RE: REVISED DRAINAGE PLAN FOR PRESBYTERIAN MAGNETIC
RESONANCE IMAGING CENTER, LTD. (K-15/D30D)
REVISION DATED AUGUST 10, 1990

RE: DRAINAGE PLAN FOR PRESBYTERIAN MAGNETIC RESONANCE IMAGING CENTER LTD
(K-15/D030D) ENGINEER'S STAMP DATED JUNE 1, 1990

PRE-DESIGN CONFERENCE

NO.	DESCRIPTION			DATE	
REVISIONS					
PRESBYTERIAN MAGNETIC RESONANCE IMAGING CENTER, LTD. GRADING AND DRAINAGE PLAN

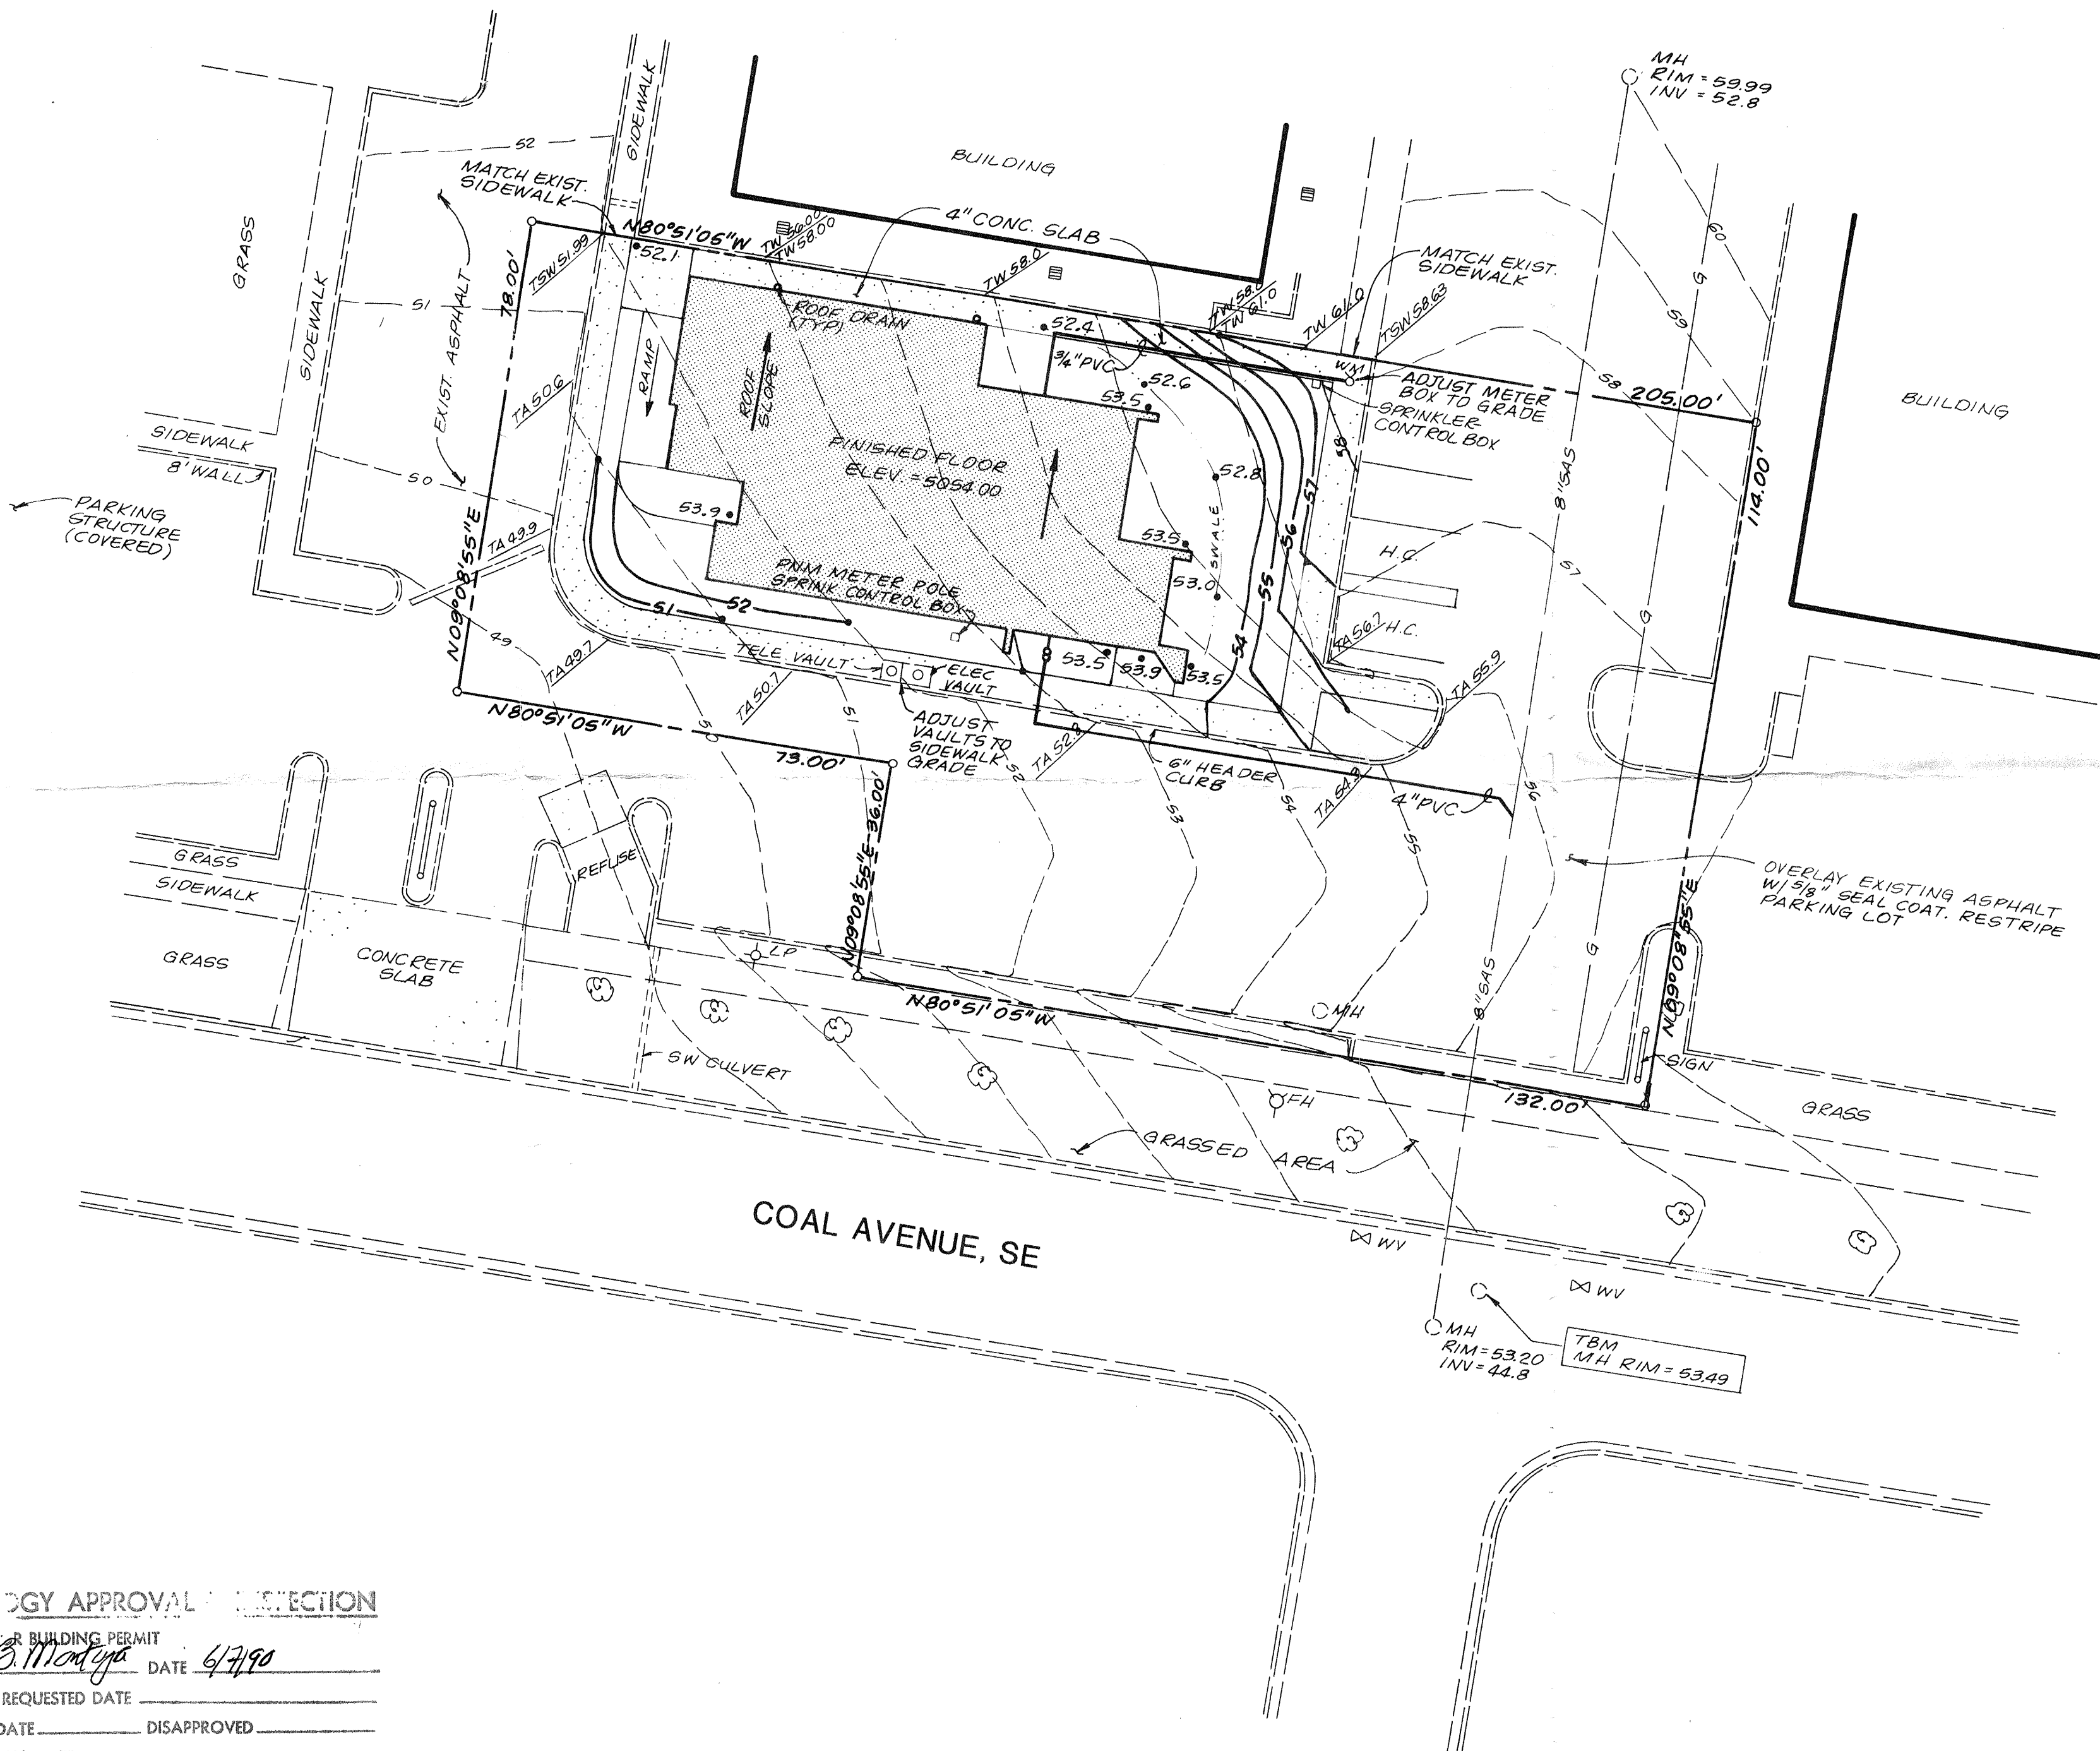
Based on the information provided on your June 1, 1990 submittal, the above referenced drainage plan is approved for Building Permit.

Please attach a copy of the approved plan to the construction sets, prior to sign-off by Hydrology.

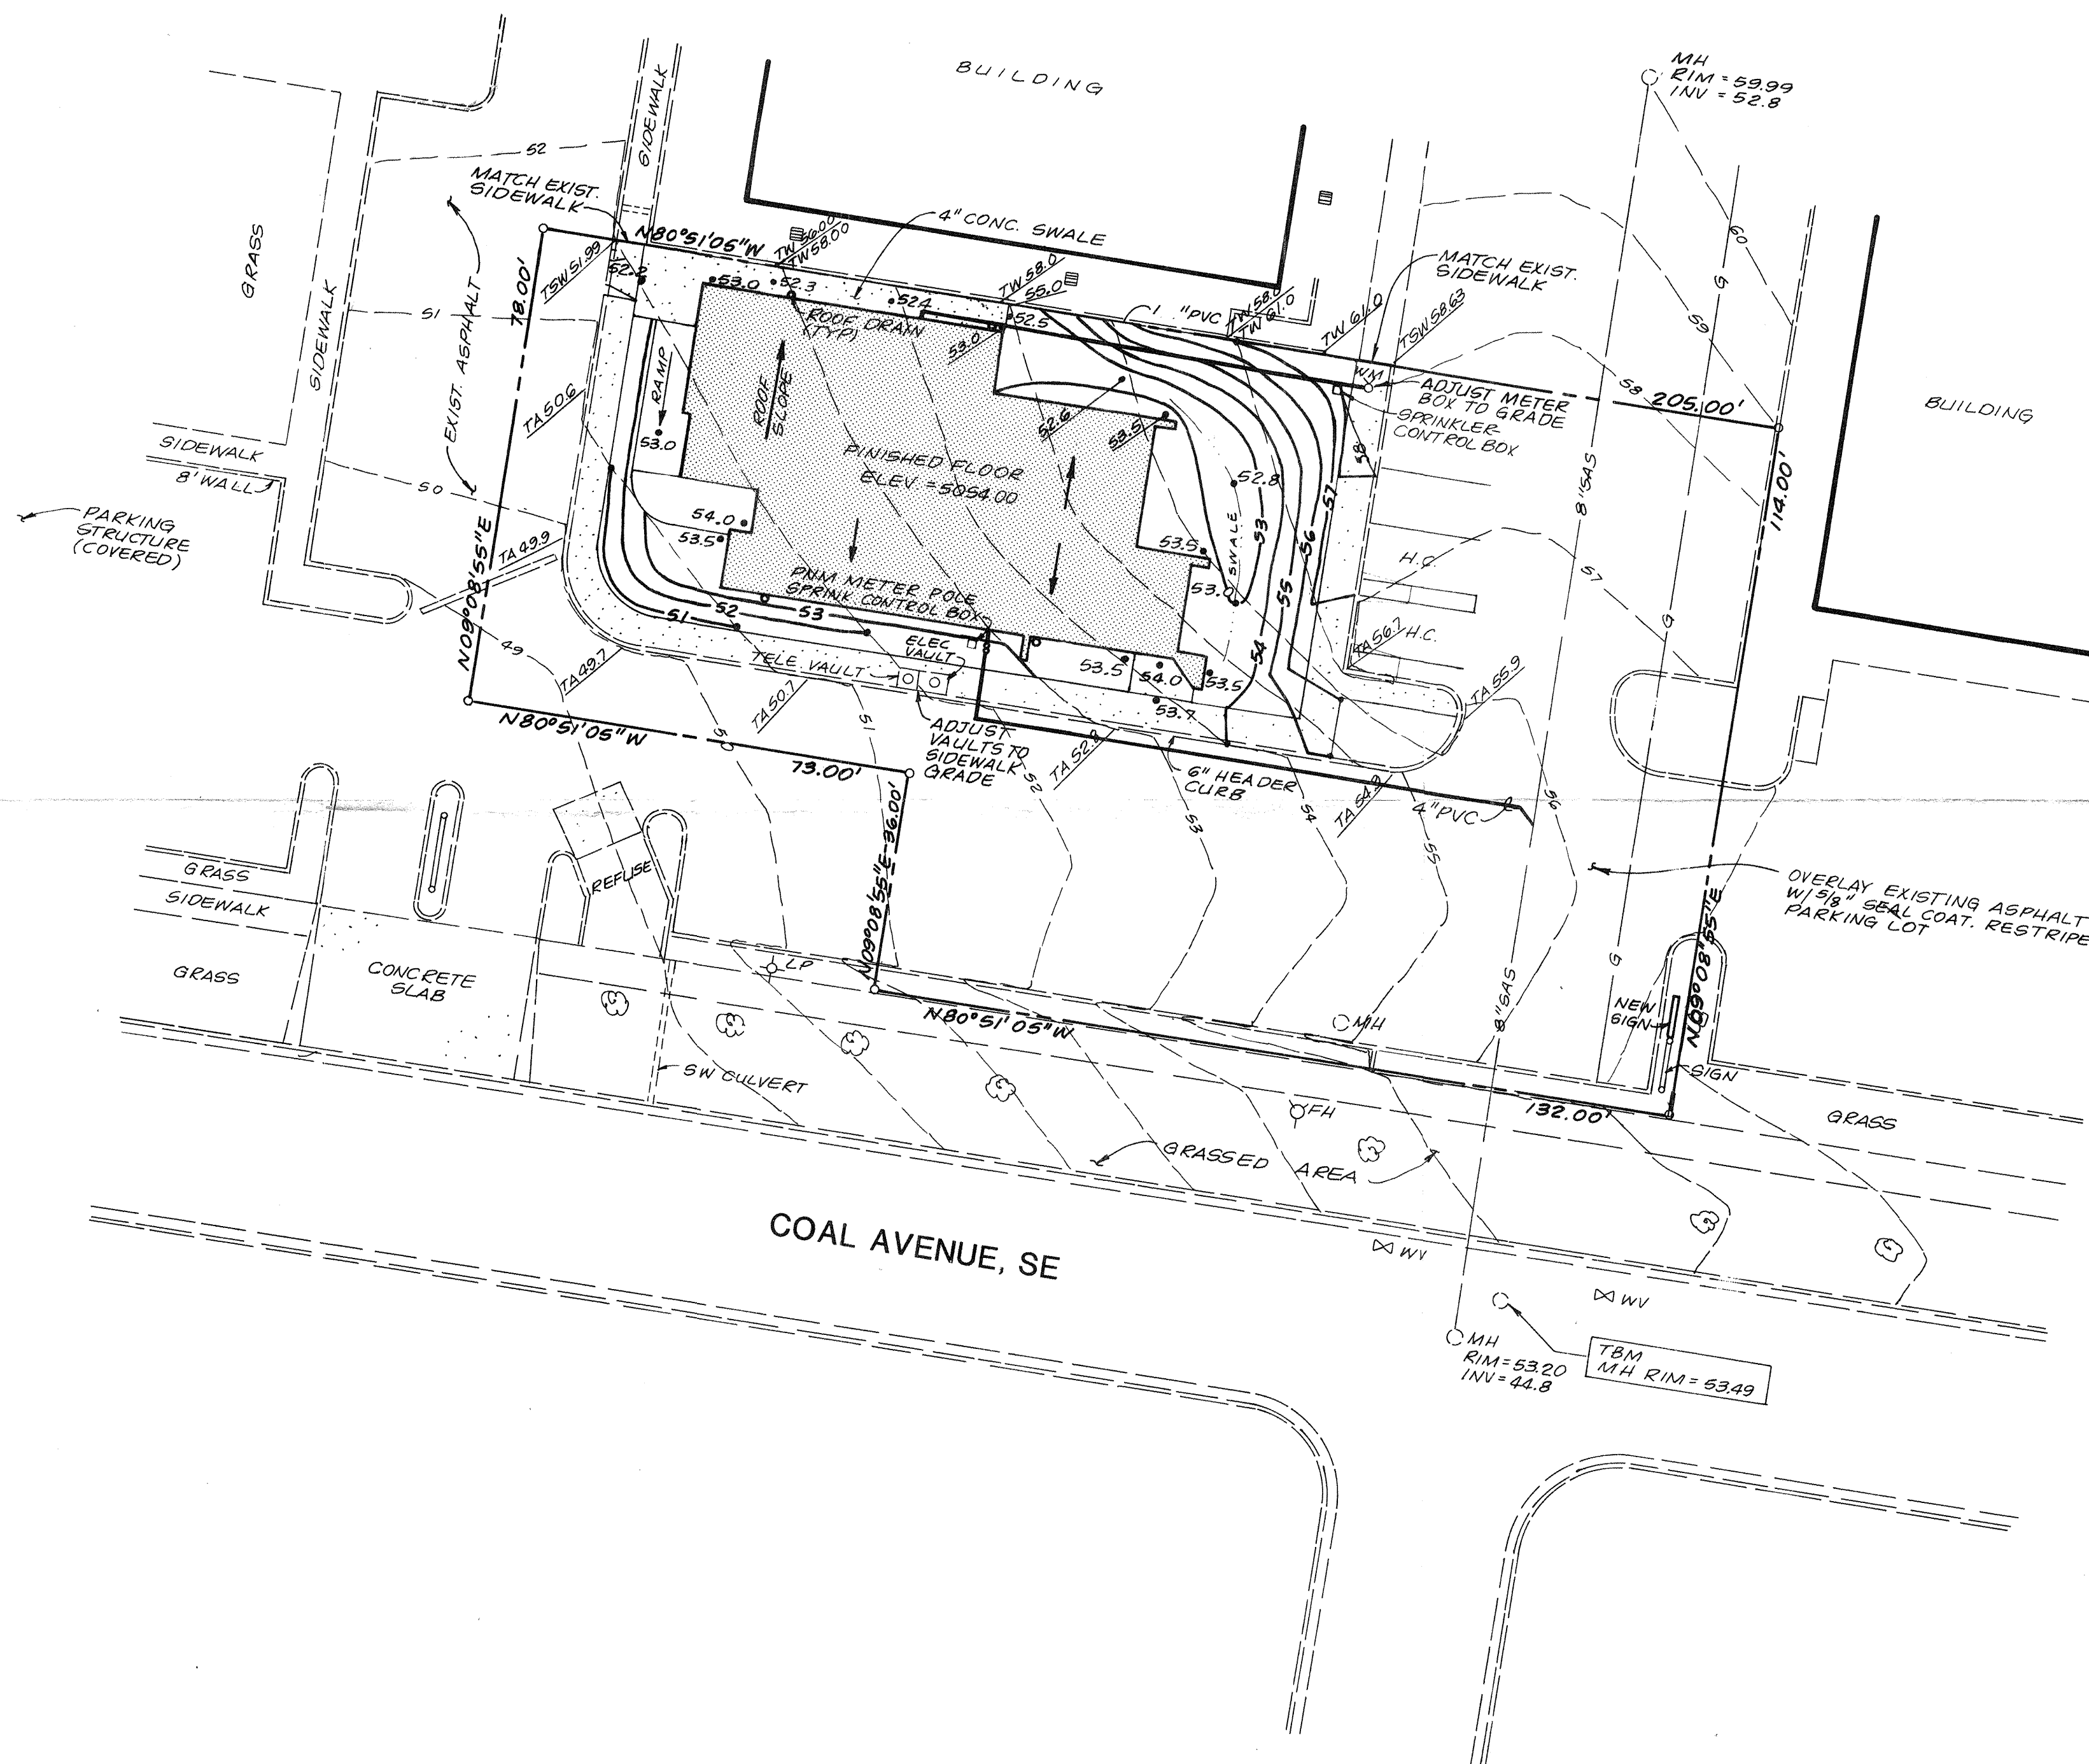
Based on the information provided on your resubmittal of august 10, 1990, the above referenced plan is approved for Building Permit.

Please be advised that if the Building Permit has already been issued, it is your responsibility to make sure the contractor is supplied with the approved revised copy.
